29<sup>th</sup> October 2024

Otago Regional Council  
Private Bag 1954  
Dunedin 9054

**Memorandum: Technical Peer Review of the Assessment of Effects of Discharges to Air: Oceana Gold NZ Ltd Macraes Mine MP4 Expansion**

Figure 6-2. Sites DG03 and DG15 windroses (hourly averages) from 1 January 2018 – 31 December 2022 (Met data provided by OGNZL).

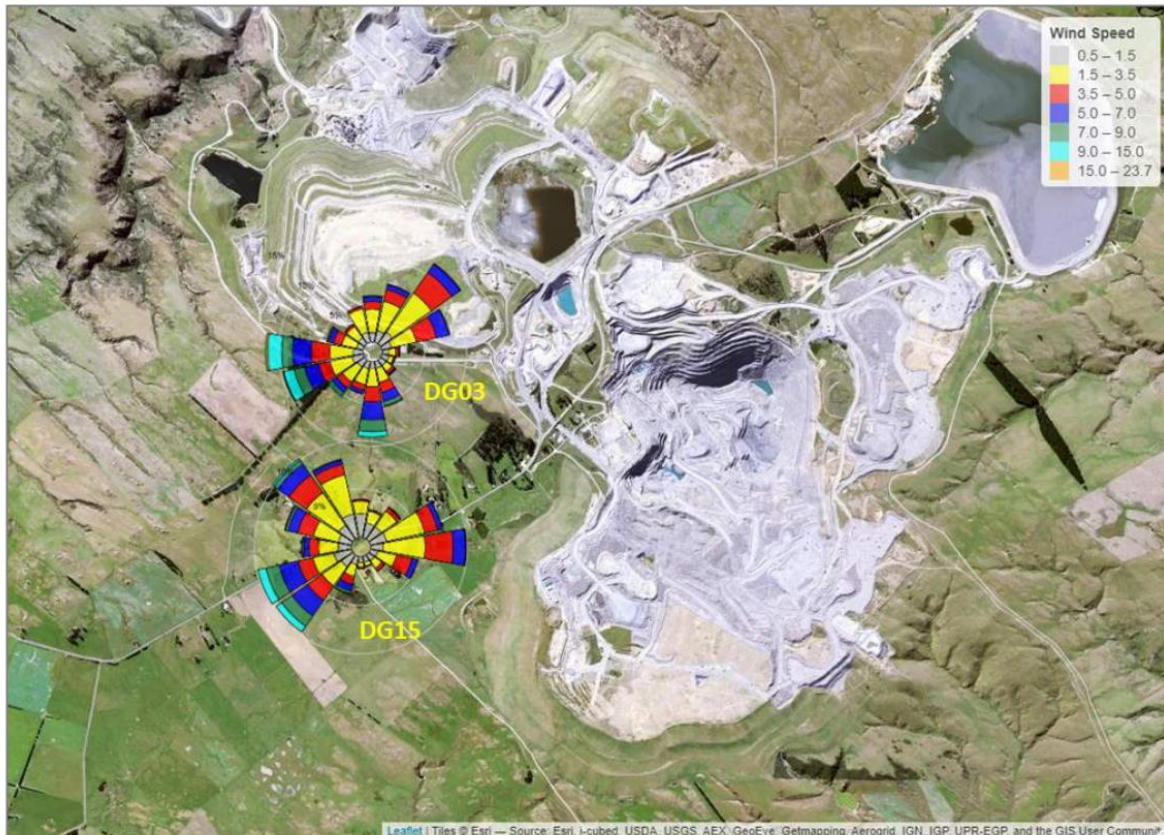
Meteorological monitoring occurs at sites DG03 and DG15 close to the village. Beca has provided wind roses of the recorded data for 2018 to 2022, as shown in the figure below. The wind roses indicate that prevailing winds are from the southwest, northwest and northeast quarters. The strongest winds blow from the northwest and southwest quarters.

The analysis of local wind conditions indicates that light to moderate strength winds from the eastern quarter are common. These winds will blow from the large area of central mining activity (Fraser's and Innes Mills) towards Receptor R1 and the village for approximately 31% of the time, based on the DG15 (Macraes village) data.

Figure 6-3. Sites DG03 and DG15 wind roses (hourly averages) of wind speeds >5m/s from 1 January 2018 – 31 December 2022(Met data provided by OGNZL).

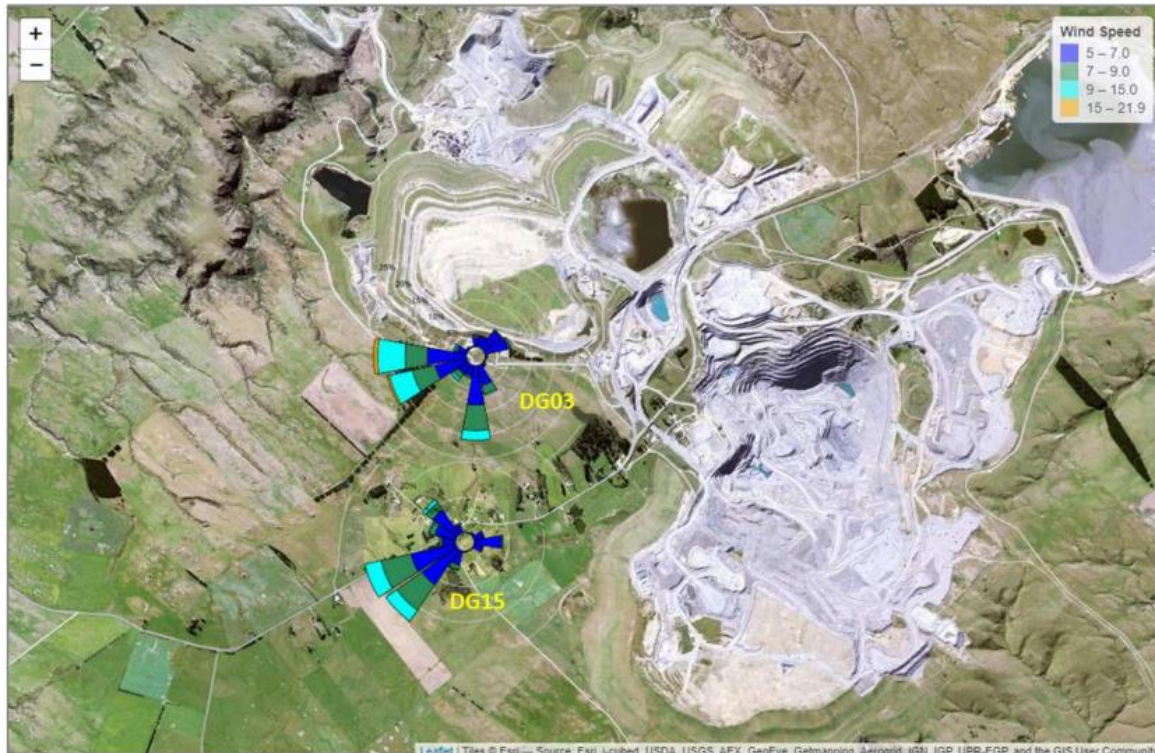
Beca notes that winds from this direction have greatest potential to transport dust at wind speeds greater than 5m/s. Based on the DG15 data, these winds occur for approximately 2.7% of the time. The figure below, reproduced from the Beca AEE, shows the wind roses when only wind speeds greater than 5m/s are included.

In general terms I agree with Beca that wind speeds of greater than 5m/s have the greatest potential to transport dust for significant distances, particularly in relation to entrainment of dust from the large areas of exposed surfaces involved. However, I note that some activities undertaken will generate relatively fine particulate matter with potential to be transported significant distances, even at lower wind speeds, when dry conditions prevail. In relation to this application, the haul road serving the Innes Mills and Frasers pits is a potentially significant dust source that can generate finer particles subject to transport for substantial distances, even at lower wind speeds, if appropriate mitigation is not applied.

Figure 3-4. IM and Frasers Pit sensitive receptors

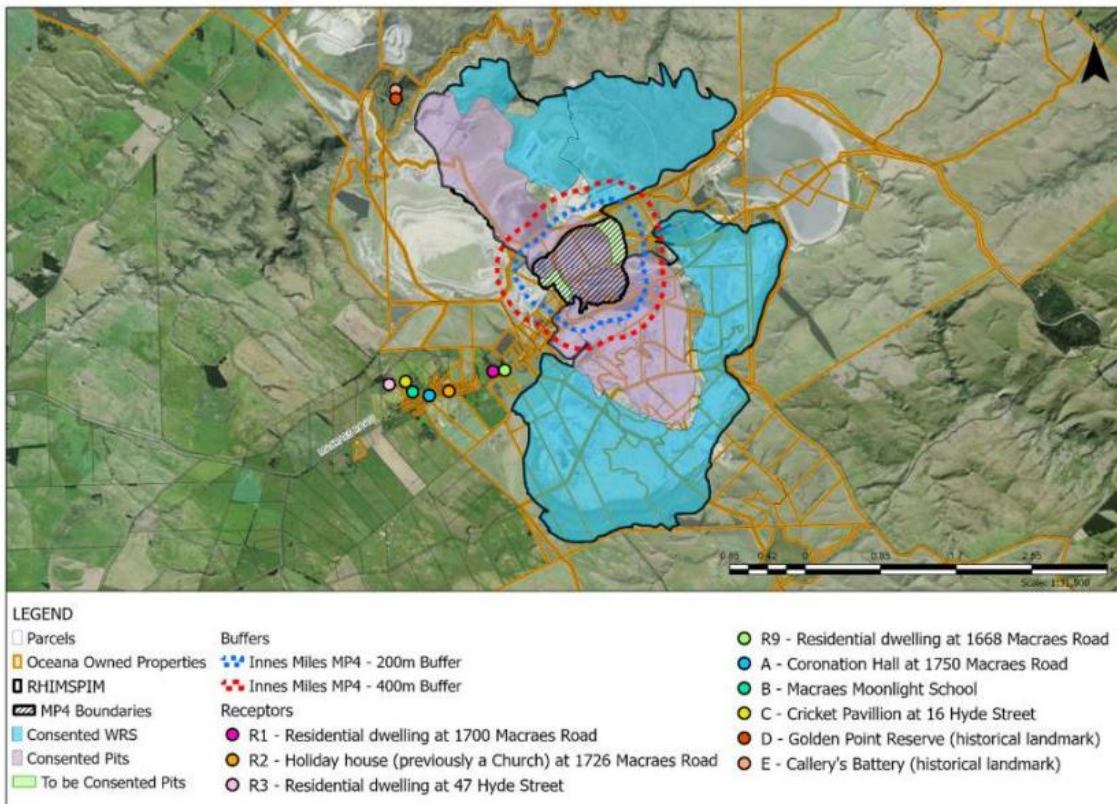
The location of receptors in the Macraes village area is shown in the image below, taken from the Beca AEE. Note that R9 (shed) is no longer classified as a sensitive receptor and the correct address for R1 has been confirmed by Beca as 1668 Macraes Road.

Figure 3-3. Receptor R5, D & E separation distances

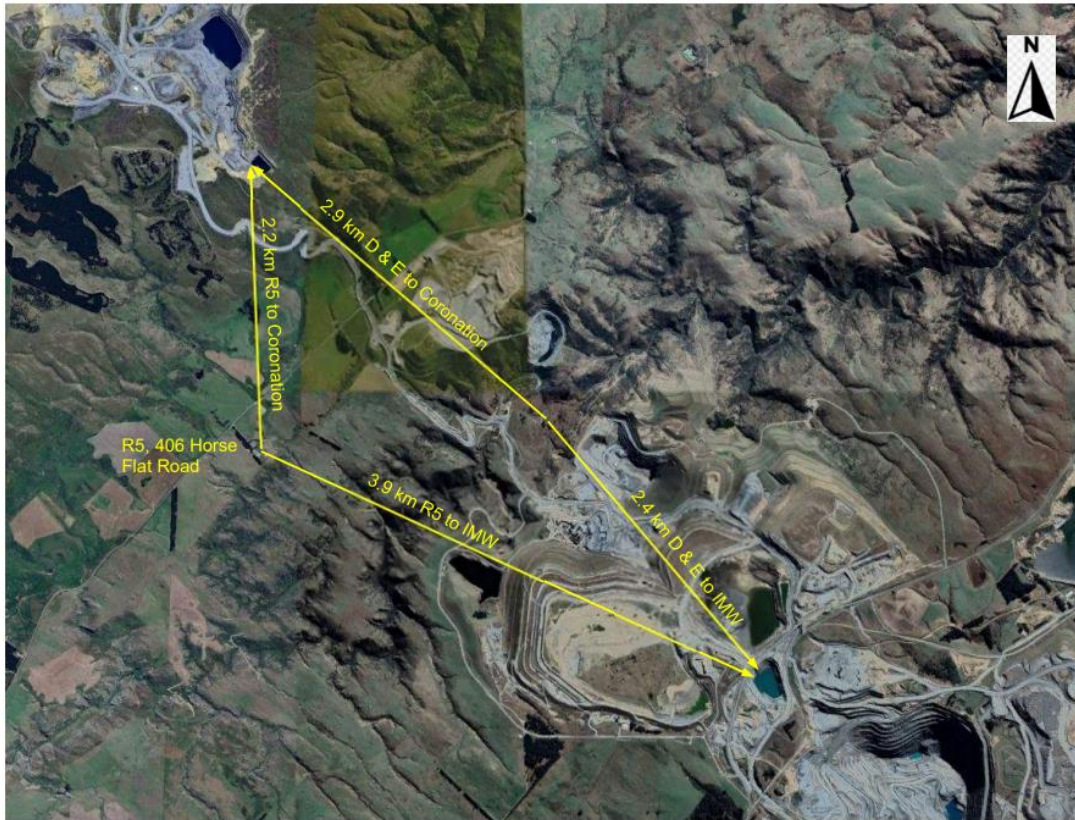
The location of receptor R5 at Horse Flat Road is shown in the image below, taken from the Beca AEE. The location of the haul road is visible.
